## **Attachment D**

### **Comment Letters**

**RE: Comments on Middle Santa Ana River Bacterial Indicator TMDL Staff Report and Basin Plan Amendment**

## RE: COMMENTS ON THE DRAFT MIDDLE SAR PATHOGEN TMDL

## EXHIBIT "A"

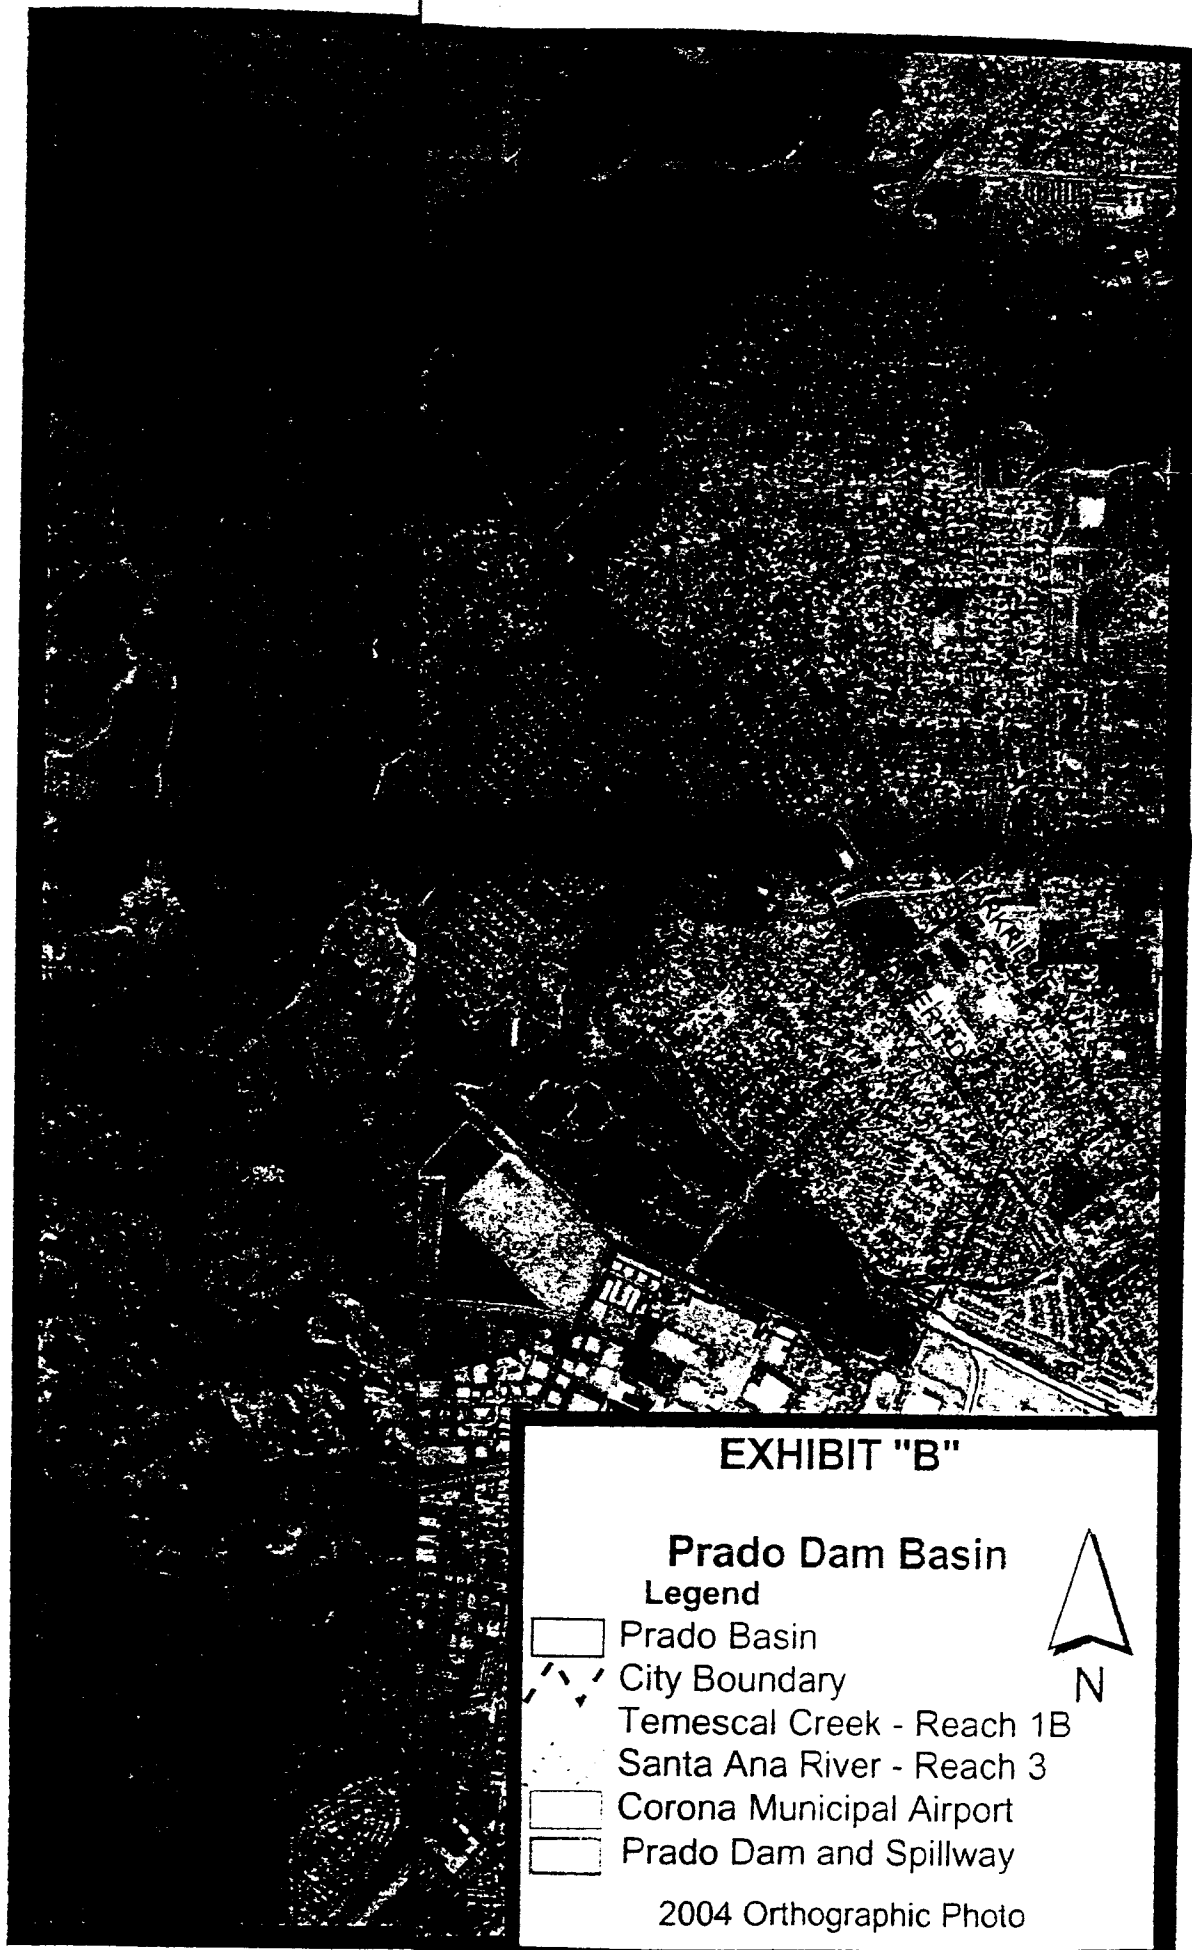
As stated in our letter to the Regional Board on June 7, 2005, we would like to take this opportunity to address the drainage characteristics of the Temescal Canyon Sub-watershed in relation to the Santa Ana River-Reach 3 (SAR-3) and Prado Dam Basin. The Temescal Creek and SAR-3 drain into the Prado Basin Management Zone. As shown on Exhibit B, the Prado Dam Basin 100-year floodplain creates this management zone. However, there is not a true confluence between the Temescal Creek and SAR-3 as indicated in the Basin Plan. Flows are spread in dense vegetation

and do not move along a flow path as they do in the upstream segments, creating a wetland environment. All sampling as part of this TMDL study were collected along the SAR-3 upstream of the Basin. Some sampling was performed downstream of the Prado Dam along SAR-2, however all Chino Basin streams, SAR-3 and Temescal are tributary to this point. Water quality at this site is also affected by wetlands processes in the Prado Basin. Thus it seems inconclusive that the Temescal watershed contributes to the pathogen impairment identified for SAR-3 and we believe should not be included in this TMDL.
